CONSTRUCTION PLANS

(AS BUILT)

TOWNE PARK PLAZA

RECORD DRAWINGS, DATE: 9-23-92

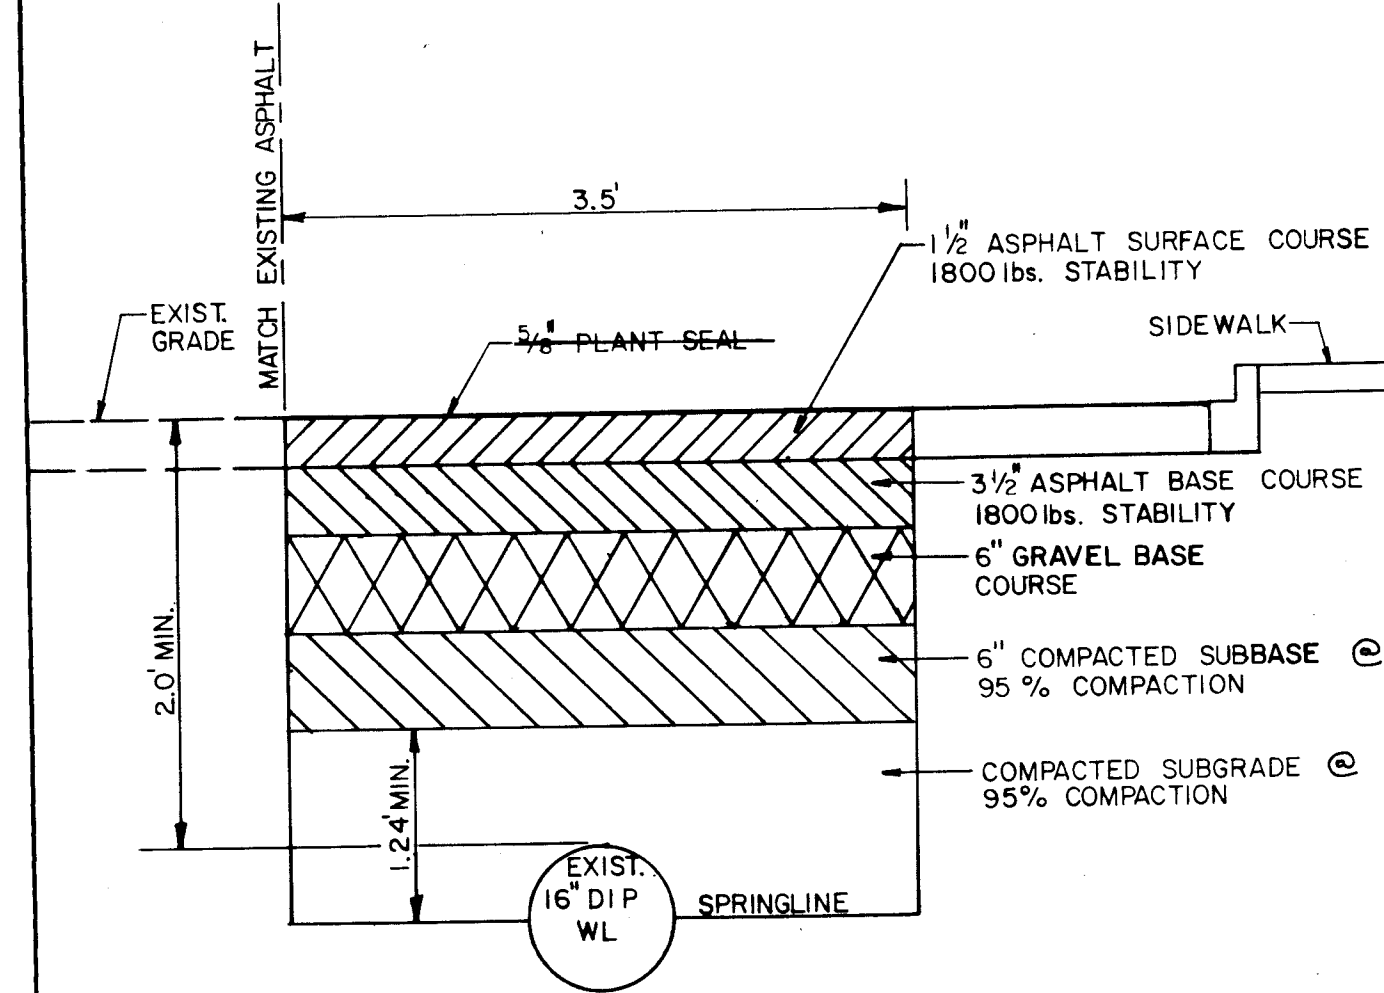
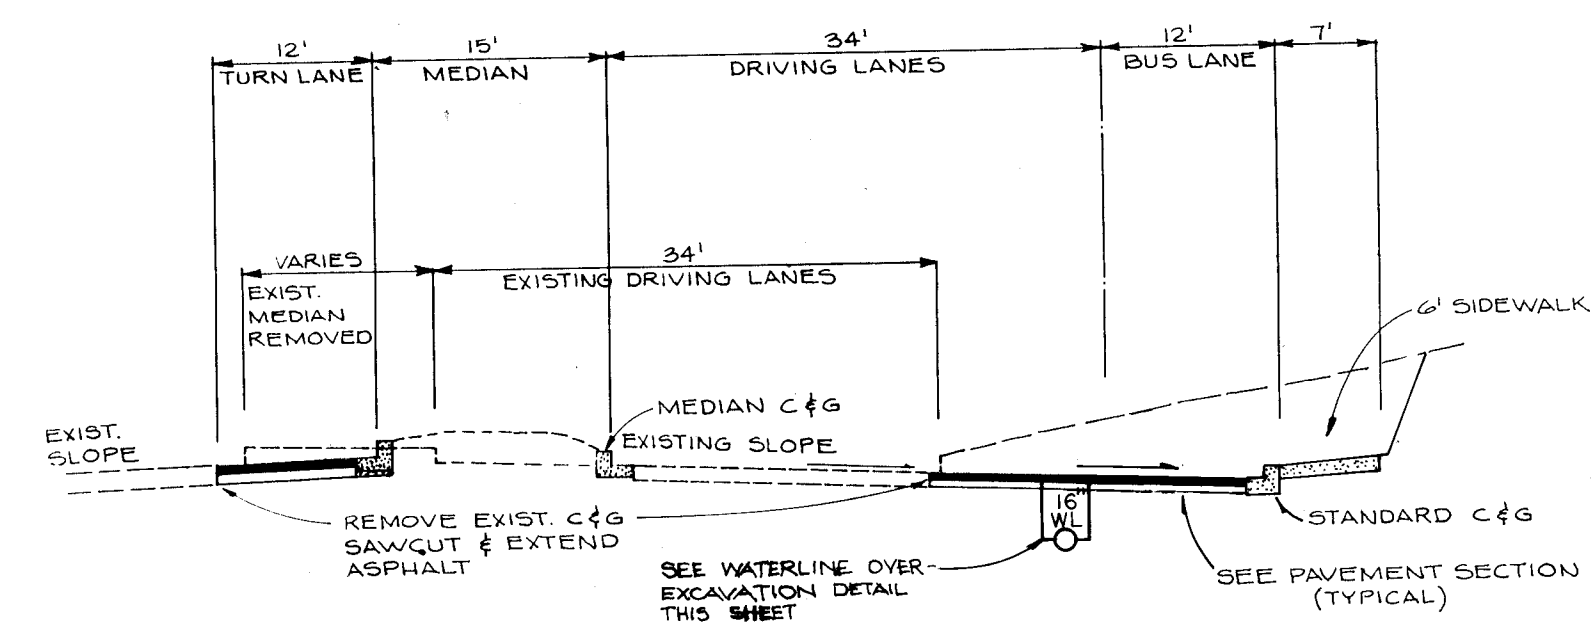
- DELETE ~~TYPE III~~ INTERIM IMPROVEMENTS AS SHOWN
- INSTALL 2 TYPE III BARRICADES ANCHORED IN THE GROUND
- UPON COMPLETION OF 4ND OPENING TO TRAFFIC OF THE I-40 OFF RAMP, THE FOLLOWING INTERIM IMPROV. ARE TO BE REMOVED:
 - TYPE III BARRICADES
 - TEMPORARY EXTRUDED ASPHALT CURB ON EUBANK

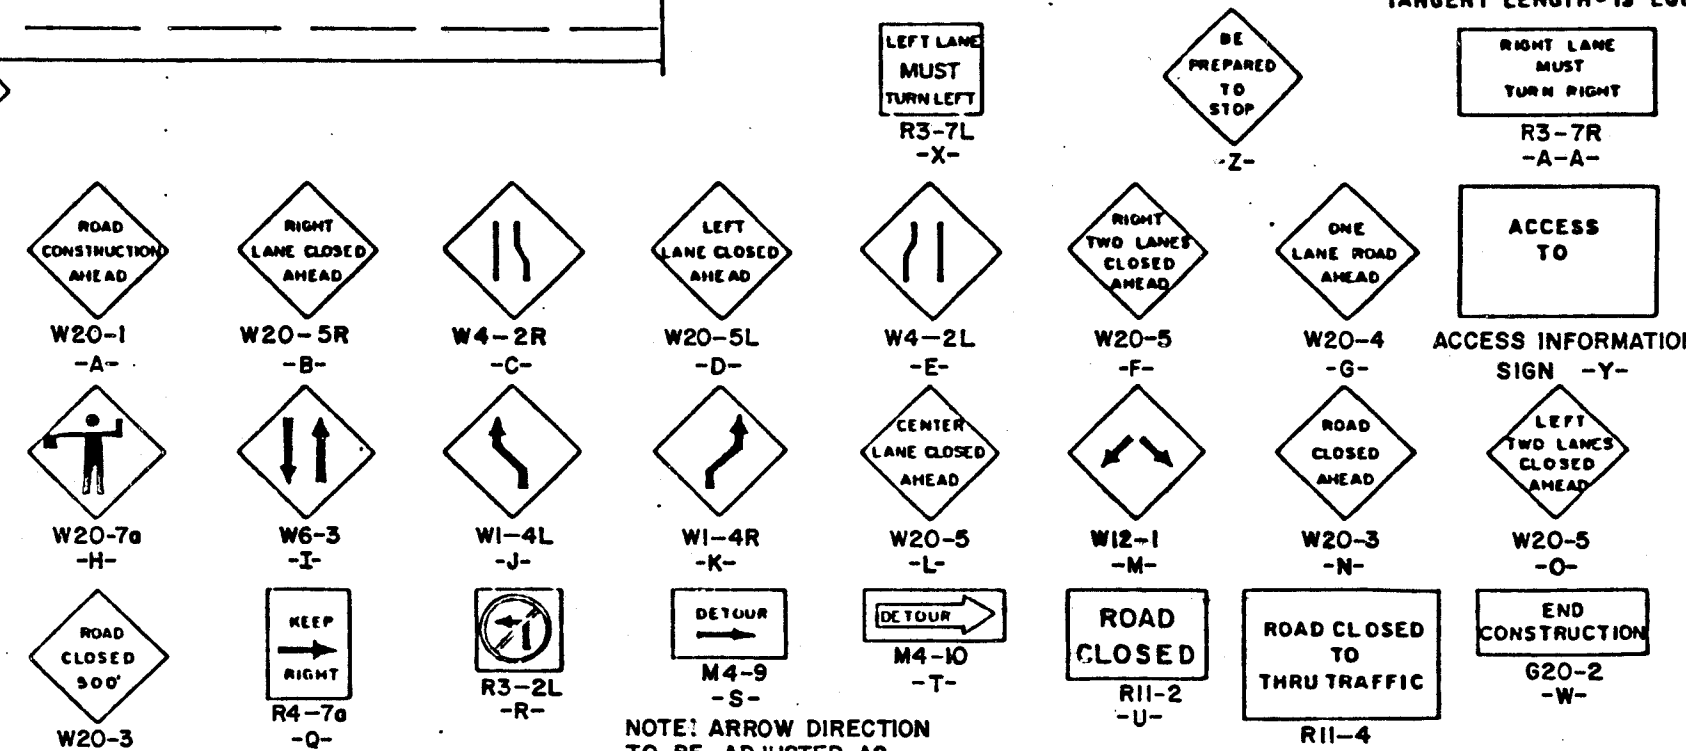
TANGENT LENGTH - IS EQUAL TO ~~THE TAPER LENGTH FOR A GIVEN STREET~~ 1/2 OF TAPER LENGTH
